ELECTRIC POWER RESEARCH INSTITUTE

January 13, 1977

Dr. S. H. Hanauer
Nuclear Regulatory Commission
Washington, D.C. 20555

At our meeting here you asked me for some further estimates on ATWS and for some indication of how I view the usefulness of probabilistic/statistical (P/S) techniques vis a vis the licensing process.

LEARNING CURVE FOR AN AVERAGE BWR; FIGURE 1

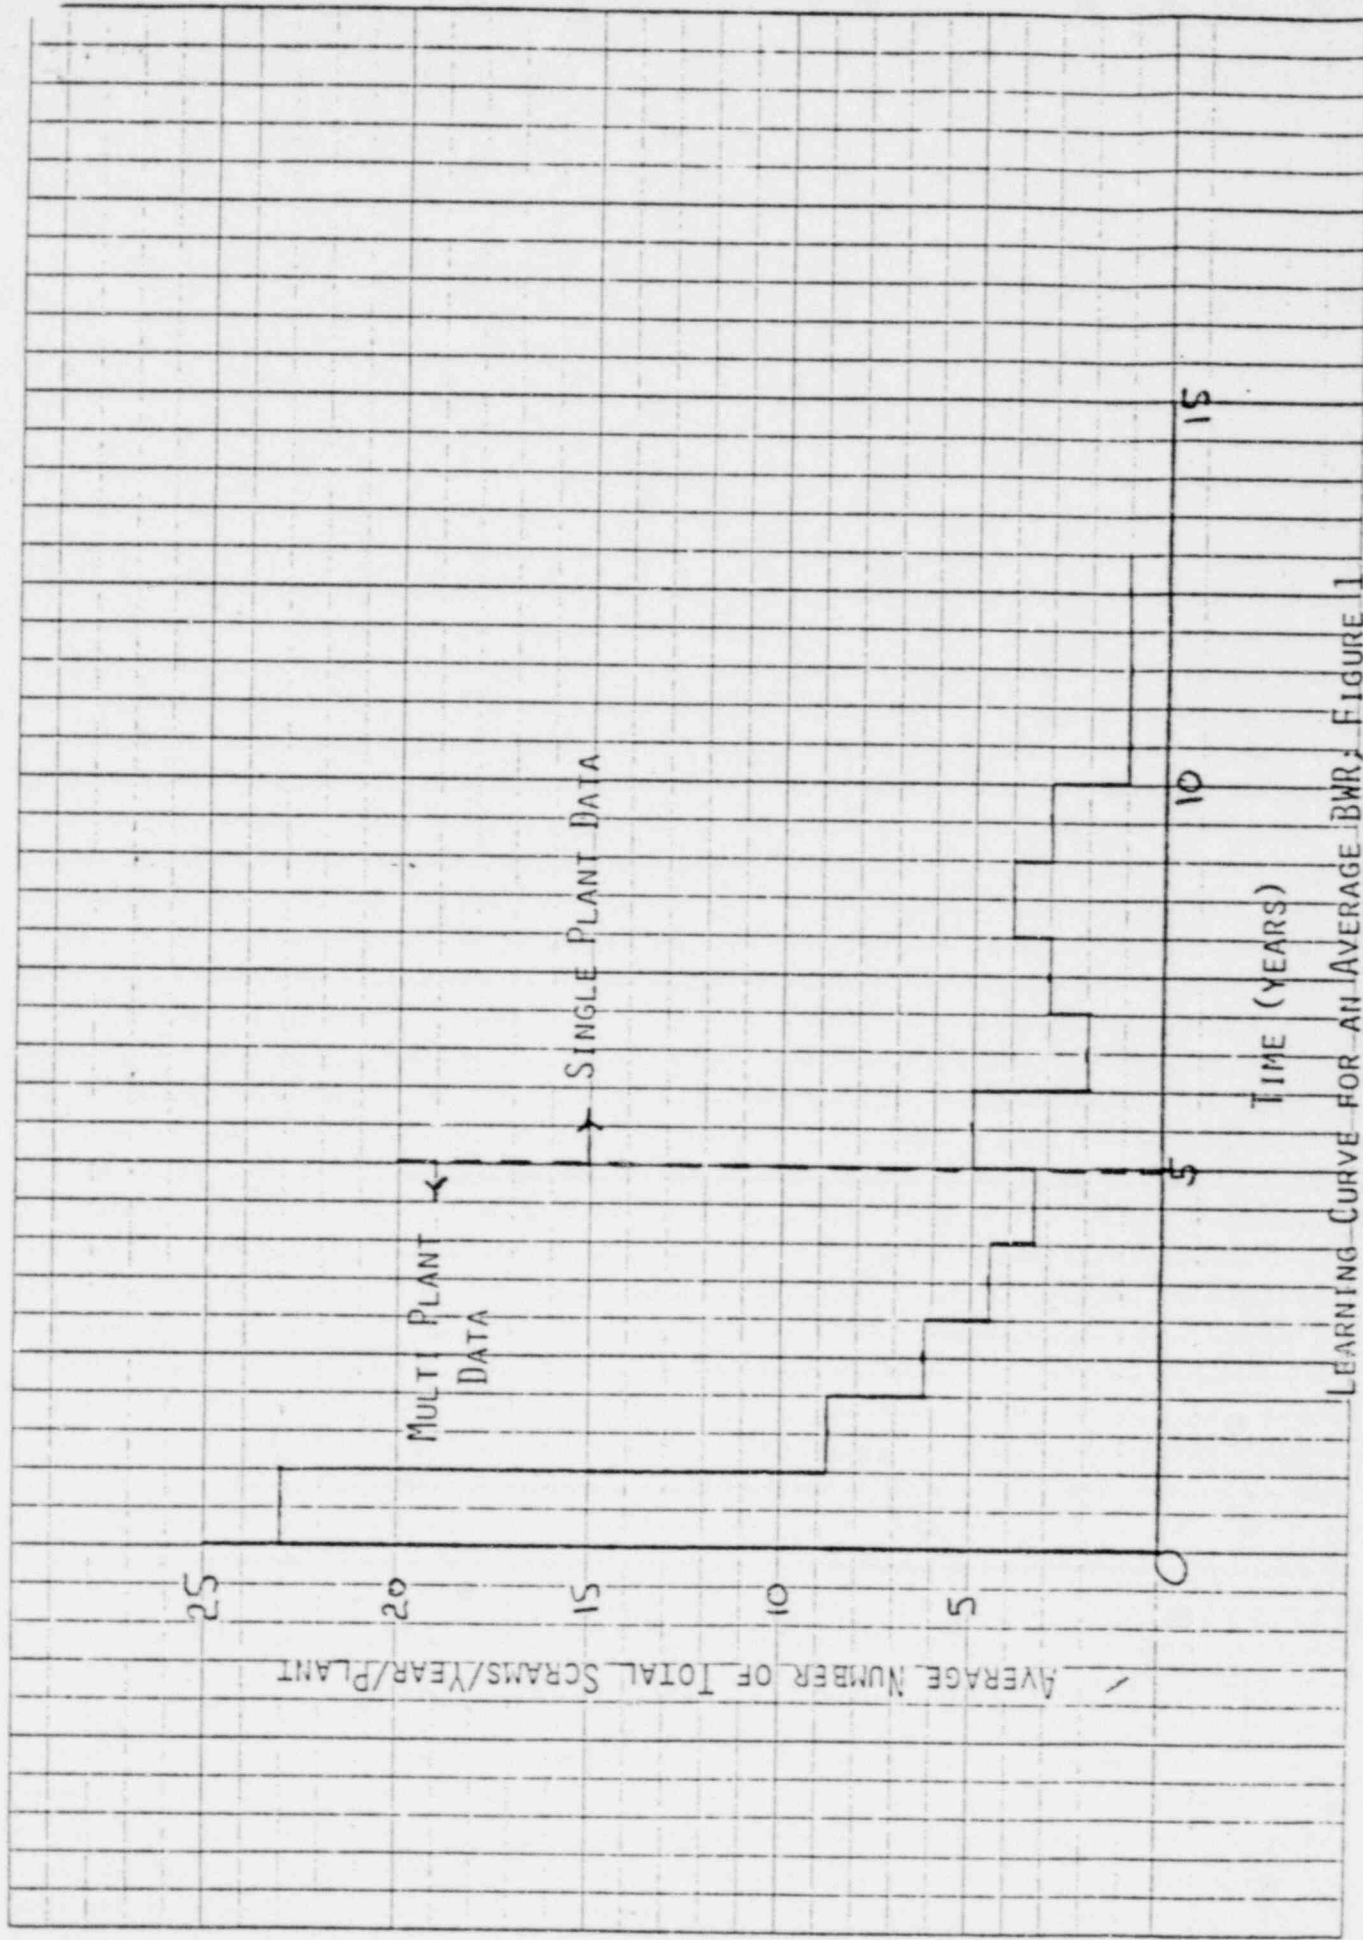
1. The NRC staff conclusions relative to the EPRI study on the number of limiting transients/year are partly correct. The variation of number of scrams/year with plant age is not accounted for (see attached graphs) in the NRC evaluation.
2. The statement that the Navy data was considered by NRC staff is correct. However, it is not clear to us that NRC staff attempted to determine the actual testing rates of naval units (hence to determine the actual total number of scram trials). If such an attempt had been made the NRC staff would have discovered, as we did, that many more trials than twelve per year were held. Alternatively, the NRC staff may have determined the actual testing rates and then not used the data.
